10/581,218

Office Action Summary	Application No. 10/581,218	Applicant(s) HOUBOLT ET AL.	
	Examiner Jason Daniel Prone	Art Unit 3724

DETAILED ACTION

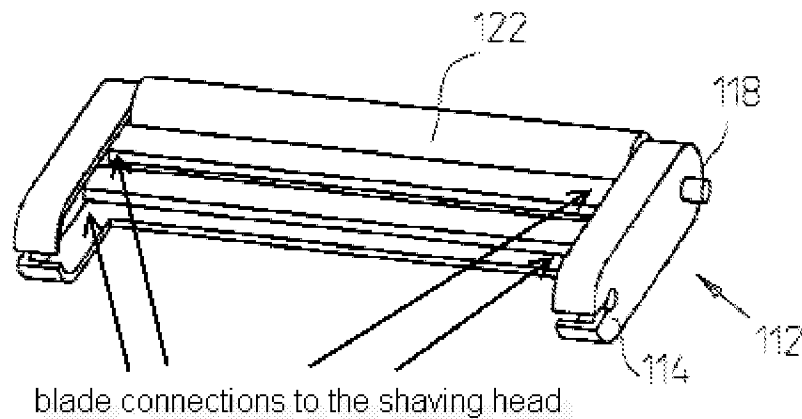
However, Avidor, as written above, discloses a force is distributed to the stretching device and the guard but Avidor fails to disclose the force is distributed equally to the stretching device and the guard.

Apprille Jr. teaches it is old and well known in the art of pivoting razor heads to balance out the force distribution based on the position of the pivot axis (column 2 lines

32-36 and column 7 lines 48-65). In light of Apprille Jr., it would have been well within one technical grasp to have balance out any two working portions designed to interact with the skin. In other words, it would have been obvious in Avidor to have moved the pivot axis 132 to a spot on the back of the razor to allow the forces to distribute equally to 104 and 122. Now the combination of Avidor in view of Apprille Jr. discloses the blades being substantially in-line with the first coupling (there is a straight line from the first blade to the coupling and there is a straight line from the second blade to the coupling) that is offset from the cutting edges (132). It would have been obvious to one having ordinary skill in the art at the time the invention was made to have distributed forces equally to the stretching device and the guard, because it has been held that where the general conditions of a claim are disclosed in the prior art, discovering the optimum or workable ranges involves only routine skill in the art and it has been held that discovering an optimum value of a result effective variable involves only routine skill in the art. Therefore, it would have been an obvious matter of design choice to modify the device of Avidor to obtain the invention as specified in claim 1. The claim would have been obvious because a person of ordinary skill has good reason to pursue the known options within technical grasp. If this leads to the anticipated success, it is likely the product is not of innovation but of ordinary skill and common sense.

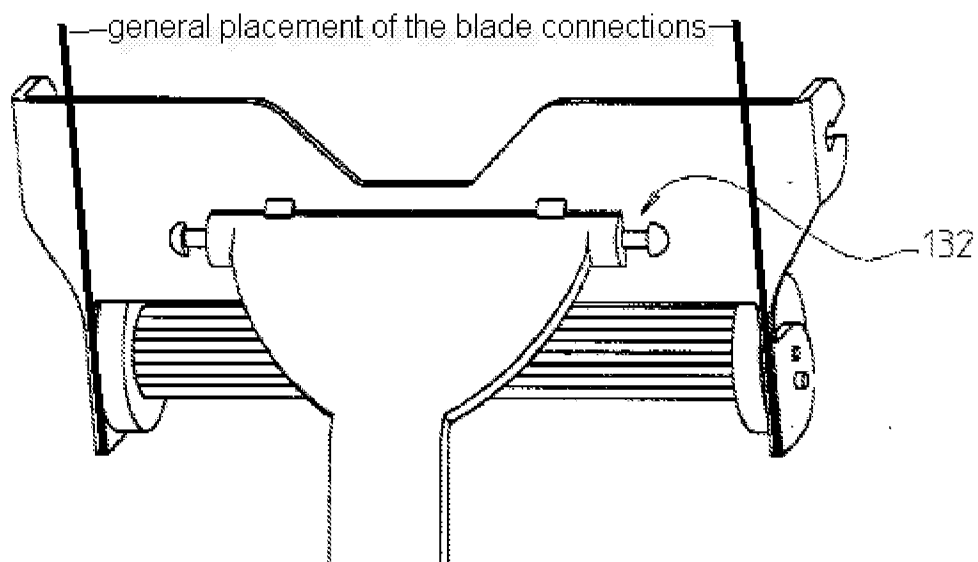
coupling and pivot axis is arranged between (see Figures below) and substantially in-line (there is a straight line from the first blade to the coupling and there is a straight line from the second blade to the coupling, therefore the coupling is in-line with each of the blades) with where the two cutting blades are coupled to the shaving head.

The blades are coupled to the outer edges of the shaving head.

The added dark lines represent roughly where these blade couplings are located to illustrate the pivot axis 132 is clearly between the where the two blades are coupled to the shaving head.

8. Applicant's arguments filed 21 September 2010 have been fully considered but they are not persuasive. First, portion 112 of Avidor's Figure 16 is considered part of the shaving head. With regards to claim 1, the blades are clearly coupled on either side of the shaving head to walls 114 (shown in the Figure above). With regards to claims 1 and 19, in light of the fact that there is a straight line between any two points, an imaginary straight line can be drawn to connect any one of the blade/head coupling locations with the pivot axis/coupling. Therefore, each of these blade/head coupling locations is in-line with the pivot axis/coupling at any given time.
